APPENDIX F:

EPA Responses to Public Comments

Table F-1. EPA responses to public comments received from Louisiana Department of Environmental Quality

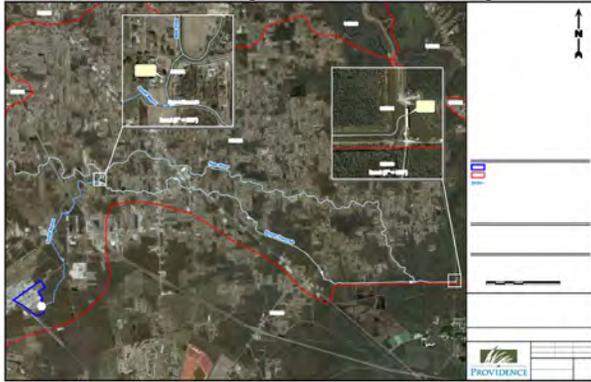
#	Comment	EPA response
1	<p>The OxyChem Geismar, Louisiana, chemical manufacturing facility is currently authorized to discharge treated process wastewater and stormwater associated with industrial activity under the authority of LPDES permit number LA0002933 issued by LDEQ with an effective date of September 1, 2007. Under the authority of the LPDES permit, OxyChem is authorized to discharge the following wastewater streams:</p> <ul style="list-style-type: none"> • Outfall 001, the continuous discharge of treated process wastewaters, process area stormwater, utility wastewater consisting of cogeneration wastewaters, boiler blowdown, north and south plant cooling tower blowdown, deionization and ion exchange regeneration, sanitary wastewater and miscellaneous industrial utility wastewaters. • Internal Outfall 101, the intermittent discharge of process wastewaters from the EDC Units (to BASF). • Outfall 002, the intermittent discharge of non-process area stormwater runoff from the chlor-alkali units, MCF area stormwater, excess capacity process area stormwater from the chlorinated organics units, railyard drain sump II, and chlor-alkali units, and miscellaneous wastewaters including but not limited to steam trap blowdown, clarified water, fire water, instrument air and compressor blowdown, and potable water. <p>Outfall 001 is discharged to the Mississippi River, while Internal Outfall 101 is routed to BASF for treatment and discharge to the Mississippi River under the authority of BASF's LPDES permit. OxyChem's current LPDES permit identifies the receiving stream for Outfall 002 as Blind River via Smith Bayou. This portion of Blind River is defined in the Louisiana Administrative Code (LAC) at Title 33:IX.1123, Table 3, as water quality subsegment 040403, "Blind River</p>	<p>Thank you for the update. The TMDL and report will be updated accordingly.</p>

– From headwaters to Amite River Diversion Canal (Scenic).” The Fact Sheet and Rationale issued with the draft permit on May 23, 2007 incorrectly identified the receiving stream as Blind River via Smith Bayou in water quality subsegment 040401, which is defined at LAC 33:IX.1123, Table 3, as “Blind River – From Amite River Diversion Canal to Lake Maurepas.”

Attached is a map identifying the OxyChem Geismar facility, the permitted final outfalls, the Outfall 002 effluent route, and LDEQ's watershed subsegment boundaries. The discharge from final Outfall 002 is made into a drainage canal; thence to Smith Bayou; thence to Bayou Francois in water quality basin subsegment 040404, which is defined at LAC 33:IX.1123, Table 3, as “New River – From Headwaters to New River Canal.” Near the intersection of Cornerview Road and Nash Drive in the City of Gonzales, a diversion canal diverts water from New River into Bayou Francois. New River and Bayou Francois then converge approximately 12 stream miles downstream at an Ascension Parish pump station, where the two streams are pumped into New River Canal. Thus, the correct description for the OxyChem Geismar Outfall 002 effluent routing is “to un-named drainage ditch to Smith Bayou, thence to Bayou Francois.”

Draft TMDLs for Total Suspended Solids, Sediment, and Turbidity for Selected Subsegments in the Lake Pontchartrain Basin, Louisiana incorrectly identifies the OxyChem Geismar facility, along with numerous other facilities, as point source dischargers to water quality subsegment 040401. Based on the information presented above and on the attached figure, OxyChem believes that the discharge from the OxyChem Geismar facility through Final Outfall 002, which first enters water quality subsegment 040404, thence subsegment 040403, prior to entering subsegment 040401 approximately 29 miles downstream, does not possess the reasonable potential to cause or contribute to elevated levels of TSS, sediment, or turbidity in subsegment 040401. Therefore, OxyChem requests that the Geismar facility be removed from the final TMDL.
